**RE:** **518 South L Street**

**FROM:** Jordan Hodges, Senior Preservation Coordinator  
Abraham Fogel, Preservation Planner  
Department for Community Sustainability

**TITLE:** **HRPB Project Number 21-00100076:** Consideration of a Certificate of Appropriateness (COA) for window replacement for the property located at **518 South L Street**; PCN #38-43-44-21-15-167-0070. The subject property is a contributing resource to the Southeast Lucerne Local Historic District and is located in the Single-Family Residential (SF-R) zoning district.

***Example: 331 South Federal Highway***

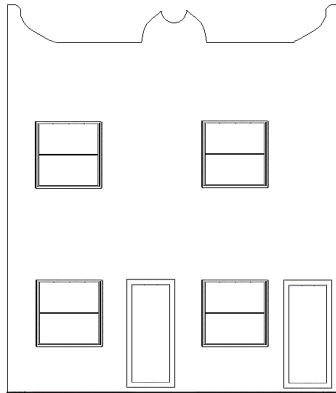
*Before: Mixture of original wood double-hung windows and replacement awning windows*

*After: Aluminum Single-Hung and Horizontal Rollers Replacement Windows*

**Staff Recommended Options**

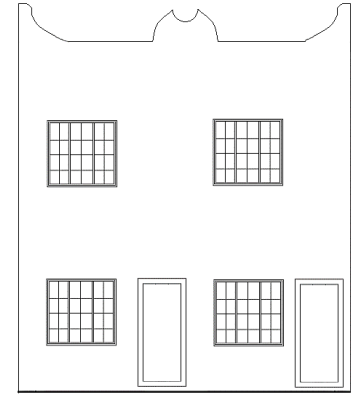
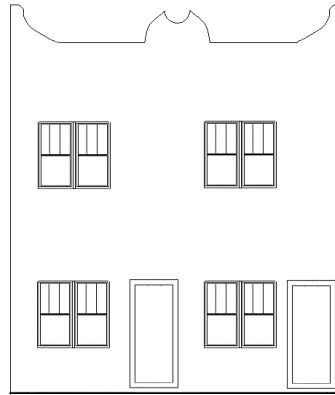
Administratively, staff could approve single-hung windows with or without decorative light patterns on the top sash for the majority of windows. The front façade features horizontally-oriented single-hung windows that are atypical for Mission Revival structures. Staff recommends that the four (4) windows on the front façade match the north and south elevation’s configuration of paired openings separated by a mullion. Alternatively, a triplet of casement windows or horizontal rollers (equal thirds configuration) with decorative light patterns could be replicated as this was a common configuration for Mission Revival structures, depicted on the next page:

**Proposed Window Replacement**  
*Utilizes horizontally-oriented  
single-hung windows*

Utilizes paired single-hung windows separated by a mullion or a triplet of casement windows/horizontal rollers (equal thirds configuration)

As discussed in the property development history, the openings on the front façade received approval in 2001. Therefore, these openings can be replaced in-kind by the property owner although it is not the *most successful* approach to replicating original windows in a Mission Revival structure.
